MEMORANDUM

REVIEW TYPE: Pre-Preliminary Plan Review

PROJECT NAME: Chevy Chase Section 1A Lots 24 & 25

CASE #: 7-04013

PRELIMINARY CONCEPT PLAN
 RESUBMISSION OF LOTS 24 AND 25, BLOCK 7
 SECTION 1-A

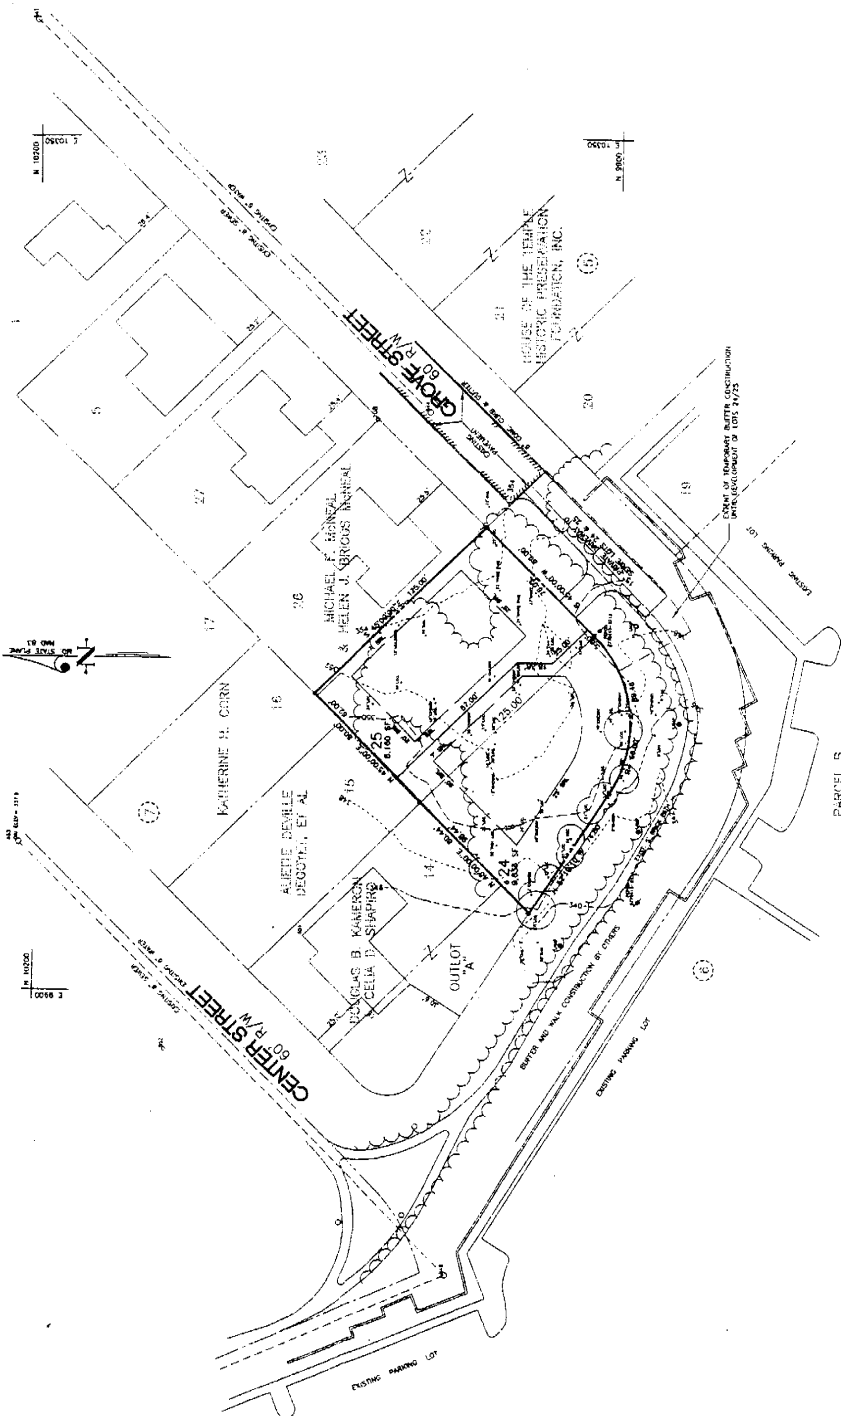
The proposed resubdivision entail adjustments of the common lot line between Lots 24, which is a corner lot, and 25, which is a rectangular lot, at the street frontage. The resulting reconfiguration would not change the external shapes of the two lots. Lot 24 would continue to be a corner lot and Lot 25 would continue to be rectangular in shape lot. The common lot line between the two lots however will be irregular with a slight bend approximately 25 feet from the street line. This bend or jog in the line will create a common lot line out of character with those other lots within the neighborhood. The common line would no longer be exactly perpendicular with the street line.

The staff review identifies the one criterion upon which the proposed resubdivision fails: shape. It should be reiterated that the Planning Board must find that the proposed resubdivision substantially meets all of the resubdivision criteria. The realignment of the common lot line between Lot 24 and Lot 25 will be designed in an unusual fashion creating lots with shapes inconsistent with the rectangular configuration currently found in the neighborhood. Staff is additionally concerned that the bend or jogging pattern could set a precedent for other lots both within the defined neighborhood and in other locals. Lot lines are commonly set back the required distance from existing or proposed buildings, generally in a parallel fashion. By allowing lot lines to bend or jog indiscriminately would create building envelopes highly irregular and inconsistent with existing lotting and development patterns within established neighborhoods. Therefore staff is recommending that a preliminary plan application not be submitted for this property as is currently configured.

Staff is currently working with the applicant and the Village of Chevy Chase to find an alternative lotting pattern that could satisfy the Village's desires to maintain and enhance the existing tree buffer along the common areas as well as be supportable under Section 50-29(b)(2) of the Subdivision Regulations.
